# GOVALLE NEIGHBORHOOD PARK POOL IMPROVEMENTS

# **Public Meeting 2 Summary**

Prepared by Asakura Robinson June 2016

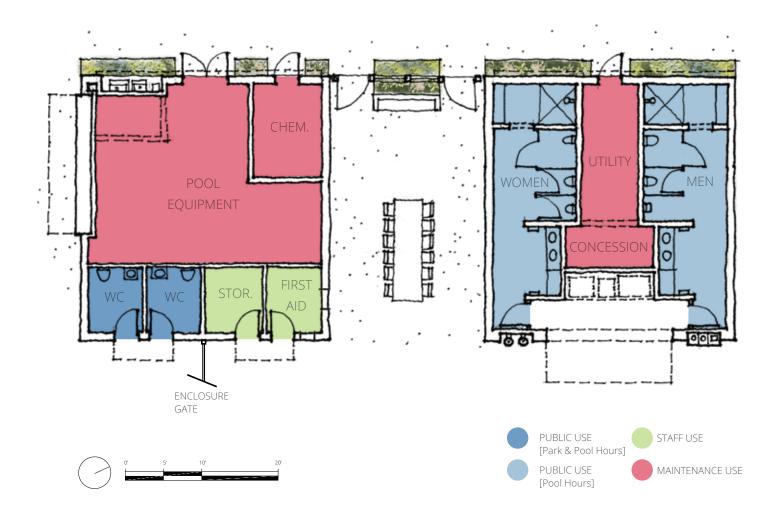
There were few comments about the proposed pools and deck areas. One participant was concerned about the life expectancy of the central oak tree. She warned that it would be lost in 20 years, and that a tree planting program should be put in place. There was also a discussion of whether the pools would be salt water or chlorine. An additional recommendation was that a water bottle filling station should be provided at the pool house, perhaps outside of the gate.

Some community members were concerned about existing access to the park. The bridge along Airport Boulevard is thought to be dangerous for pedestrians and bicyclists and requires redesign to improve the accessibility of Govalle Park for people who live on the other side of the railroad tracks. Likewise, there is concern about the safety of children crossing the tracks to get to the pool.
